**Display**Date: **April 12, 1993**Subject: **CORRECTING VITC INDICATION  
ERROR FOR D-1 INPUT**Model: **BKM-1460, BKM-2085/14, BKM-2085/20**Serial No: **10,001 AND HIGHER****DESCRIPTION**

*Figure 1*

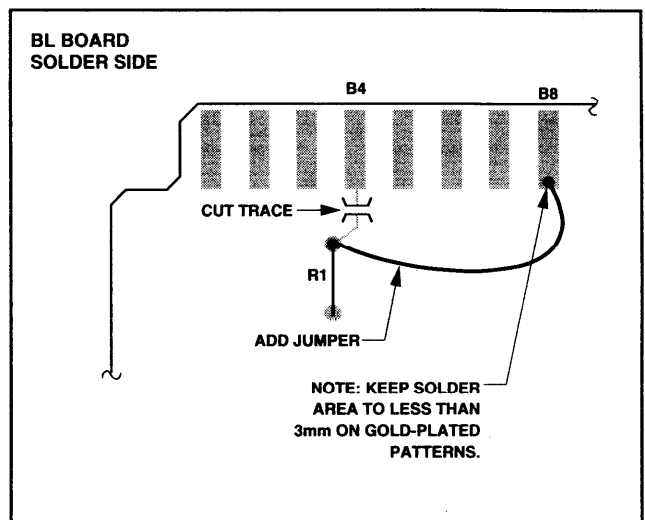
When a BKM-1460 VITC adapter is used with a BKM-2085 serial digital adapter, VITC data will not be read since it is distributed on the composite video trace in the monitor back plane. As a result, the VITC display will flash continuously. To correct this condition, perform the following modification procedure.

**MODIFICATION PROCEDURE****BKM-1460**  
**BL Board, Solder Side**  
(See Figure 1.)

1. Cut trace between R1 and connector B4.
2. Solder jumper between R1 and connector B8.

Set V-BLK switch S1 on the BV1 board to 9H. (If switch is set to 20H, VITC data will be masked by the monitor.)
